Access Compliance Report

Public Rights-of-Way

(Curb Ramps)

Intersection ID: 10025402	Main Street: E_BLAND_ST	Cross Street: N/A	Location: SE
ADA ID: E8AFA1DCEB6A	Ramp Type: Perp	Initial Pass/Fail: Fail	Overall Compliance: No
Severity Score: 12.5			
Codes/Mitigation Info/Possible Solution		Field Measurements/Component Compliance

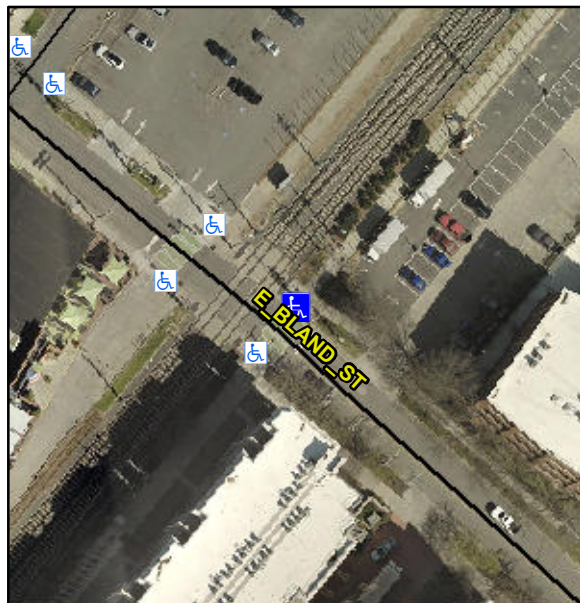
Not Found, R304.2.2

Compliance	Description	Data	Compliance	Description	Data
N/A	Ramp Length (in)	67.0	No	Ramp Slope (%)	9.1
Yes	Ramp Width (in)	91.0	Yes	Ramp XSlope (%)	0.5
N/A	Flare Type LT	N/A	N/A	Flare Type RT	N/A
N/A	Flare Slope LT (%)	N/A	N/A	Flare Slope RT (%)	N/A
N/A	Flare Traversable LT?	N/A	N/A	Flare Traversable RT?	N/A
N/A	Landing Length (in)	N/A	N/A	DWS Provided?	N/A
N/A	Landing Width (in)	N/A	N/A	DWS Contrast?	N/A
N/A	Landing Slope (%)	N/A	N/A	DWS Length (in)	N/A
N/A	Landing X Slope (%)	N/A	N/A	DWS Full Width?	N/A
N/A	Landing Curb? (Y/N)	N/A	N/A	DWS Offset (in)	N/A
N/A	Shared Landing?	N/A			
N/A	Gutter Ponding?	N/A	N/A	Gutter Slope (%)	N/A
N/A	Gutter Lip Ht (in)	N/A	N/A	Gutter X Slope (%)	N/A
N/A	Painted X Walk1?	Yes	N/A	Painted X Walk2?	N/A
	X Walk 1 Direction	To SW		X Walk 2 Direction	N/A
N/A	X Walk 1 Width (in)	171.0	N/A	X Walk 2 Width (in)	N/A
	X Walk 1 Slope (%)	2.8		X Walk 2 Slope (%)	N/A
	X Walk 1 X Slope (%)	0.5		X Walk 2 X Slope (%)	N/A

Remove & Replace Entire Ramp.
